East Anglia One North (EA1N) and East Anglia Two  
(EA2) Offshore Wind Farms

Deadline 4 - 13 January 2021

East Suffolk Council's Response to Additional  
Information Submitted by Applicants at Deadline 3

## **Review of Additional Information Submitted by Applicants at Deadline 3**

Figure 1 – Applicant’s graph of background levels with annotations added, 26/6/2018 to 3/7/2018

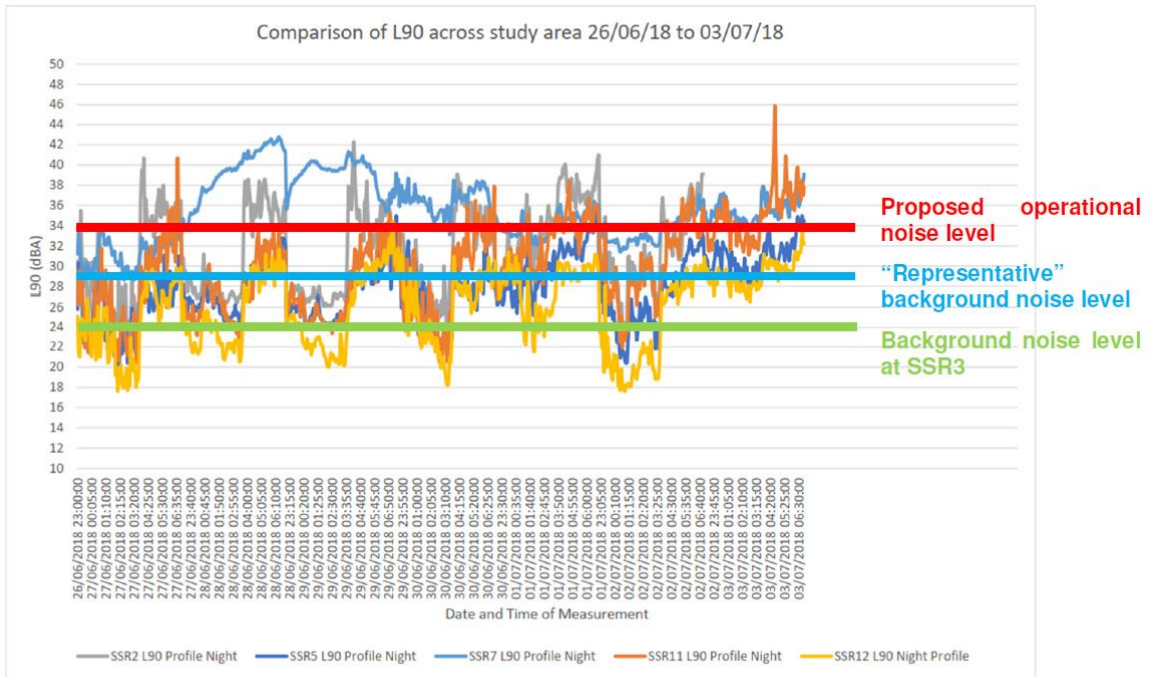
5. The typical background sound level is a key factor in establishing a target rating noise level (LAr) that is considered sufficiently protective of relevant noise sensitive receptors by avoiding significant adverse impacts. ESC therefore maintain that the target rating noise level (inclusive of acoustic feature corrections) must be established from a lower typical background sound level than the Applicants have set out to date. We have sought to illustrate this point in Figures 1 and 2 provided at the end of this Appendix.

6. Figures 1 and 2 present the Applicants' raw survey data from across the study area and between the dates of 26 June and 12 July 2018 (note that the survey locations may differ). Overlaid on these graphs are three horizontal lines. The blue line represents the typical background sound level currently adopted by the Applicants (LA90 of 29 dB). The red line illustrates where the Applicants, in Requirement 26 of the draft DCOs, have proposed a target operational rating noise level (LAr) of 34 dB. The final line (green) illustrates what ESC believe to be a more typical background sound level (at night) for the noise sensitive receptors, LA90 of 24 dB.

7. The graphed survey data from the Applicants demonstrate just how regularly night-time background sound levels fall to low levels. On many nights, the level falls below 20 dB LA90 for short periods. ESC is therefore of the opinion that the Applicants have not

11. This level (as shown in Figures 1 and 2) would exceed what we consider to be a more typical background sound level at night by 10 dB and introduce a permanent man-made sound to the existing sound climate. ESC considers therefore that the proposed operational noise level as set out in the draft DCOs would not avoid a significant adverse impact from noise at some receptors for some parts of the day.

4. ESC continues to disagree with the approach the Applicants have taken to determine a typical or representative background sound level. We therefore maintain that typical background sound levels are lower than those adopted by the Applicants to date. Our review of the Applicants' background sound survey data would lead us to conclude a typical background sound level of 24 dB LA90.

10. In summary, at this time ESC do not accept the proposed operational noise rating level (LAr) of 34 dB as set out in Requirement 26 of the draft DCOs.
